Cumloden, Pear Tree Lane, Shorne, DA12 3JZ

Annotated photos and statement to accompany release of planning condition

Statements below are taken from the delegated report from application number 20210966

Plate 1. Photo taken in March 2021 of Cumloden. Showing a timber gate in the hedge on the left and a post hole in the concrete on the right hand side of the driveway.

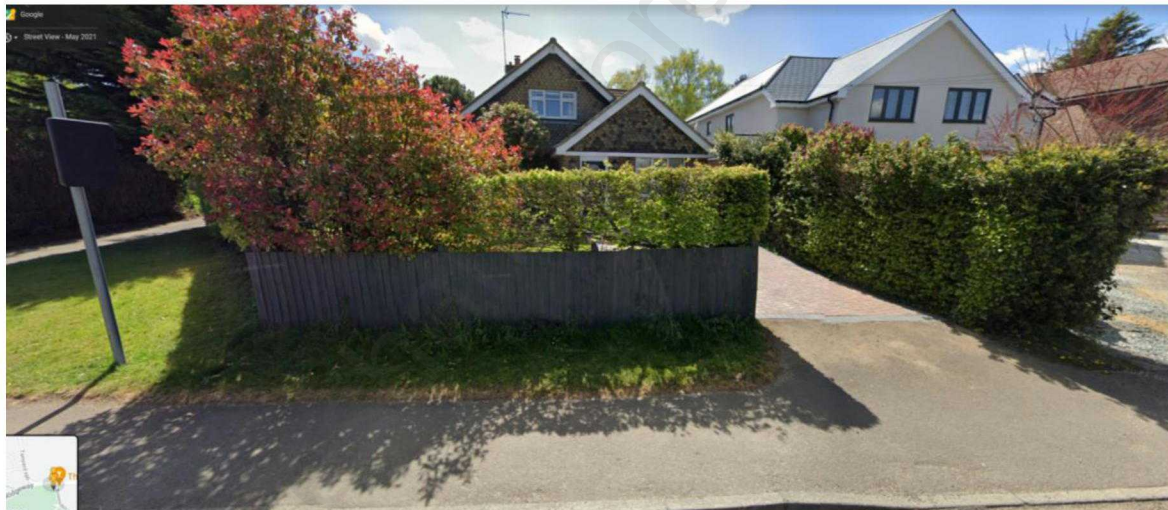
If gates are to be fitted across the vehicle entrance to your property they must not open outwards across the highway. Additionally, on busy roads they must be set back at least 5m from the edge of the carriageway to allow the driver to park clear of the highway whilst opening the gates. Remember, sufficient space must exist within the site for the gates to close.

Whilst it is accepted that Pear Tree Lane is not busy all the time, the installation of gates could set a dangerous precedent for other properties to have similar installations. As such I would oppose the installation of gates.

The proposed gates, due to their height of approx. 1.5m will not allow sufficient vision splays when exiting the driveway and the proposed electric gates will result in vehicles waiting on the carriageway for them to open thus causing an obstruction.

Comment: Gates have been present to the property for many years which plate 1 and 2 shows. Security of the site is a justified concern, especially as the owner has had cars stolen twice and the garage burglarised once. The front garden is to be enclosed with a combination of the existing hedge & fence and new hedge & gates.

The gates have been designed to be of a low height, now 1m, rather than 1.5m, and the same length and position of the previous gates. The gates will be timber to be in-keeping with the semi-rural area with close boarding to match the style of the surrounding fences and to ensure the gates are harder to climb (with security in mind) than if they were of slatted design.
